SERVICE BULLETIN

SERVICE BULLETIN NO: 57-004

WINGS - CENTER WING - INSPECTION AND MODIFICATION OF THE MAIN-SPAR DIHEDRAL FITTINGS

Aft Dihedral Fittings - Repair
Figure 5

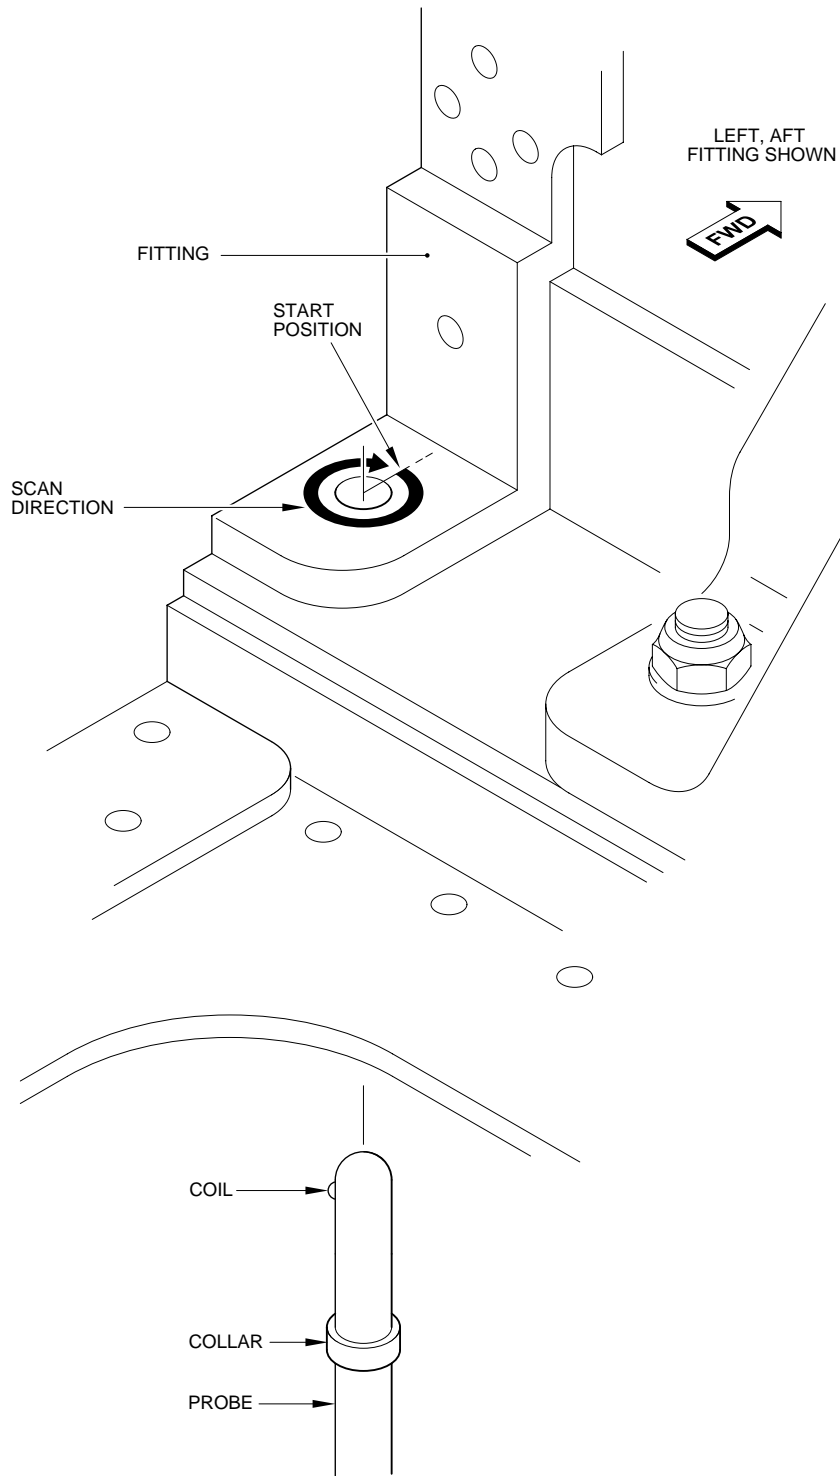
D. Modification of the Aft Dihedral Fitting and Spar-Cap Bolt Holes (Ref. Fig. 5)

Only do this modification to dihedral fittings at locations which have no cracks in the flanges. The modification removes high remaining stress from around the bolt holes so that stress corrosion will not start.

This procedure is only applicable to a left and right aft-dihedral fitting in which all four bolt holes (two upper and two lower) have no cracks.

- (4) Use an applicable drift and carefully punch the bolts through the spar and the flange of the dihedral fitting.
- (5) Use the reamer (P/N: 513.57.09.086) to increase the diameter of the bolt holes to between 5,044 and 5,070 mm (0.1986 and 0.1996 in.).

- (8) Measure the grip length of the aft fitting lower-bolt-holes to find which replacement bolt to install
- (a) If the grip length is equal to or greater than 25,2 mm, use bolt P/N: 557.10.09.056.

- (b) If the grip length is less than 25,2 mm, use bolt is P/N: 557.10.09.057.
- (9) If the aft fitting lower-bolt-hole is damaged, install the next oversize bolt

- (a) Use a reamer (P/N: 513.57.09.078) to increase the diameter of the bolt holes to between 5,440 and 5,466 mm (0.2142 and 0.2152 in.)
- (b) Measure the grip length of the aft fitting lower-bolt-holes to find which replacement bolt to install

- (10) Measure the grip length of the aft fitting upper-bolt-holes to find which replacement bolt to install
 - (a) If the grip length is equal to or less than 27,0 mm, use bolt P/N: 557.10.09.058.

- (b) If the grip length is greater than 27,0 mm, use bolt P/N: 557.10.09.059.
- (11) If the aft fitting upper-bolt-hole is damaged, install the next oversize bolt

- (12) Obey the manufacturer's instructions and apply corrosion preventative (Item No. P04-012) to the shanks of the new bolts (1), (2), (5) and (6).
- (13) Install the new bolts (1), (2), (5) and (6).

- (14) Install the new washers (3) and nuts (4). Torque the nuts (4) to between 4,0 and 5.0 Nm (35 to 45 lbf in.)
- (15) Clean unwanted sealant from the bolt head, nut and washer.
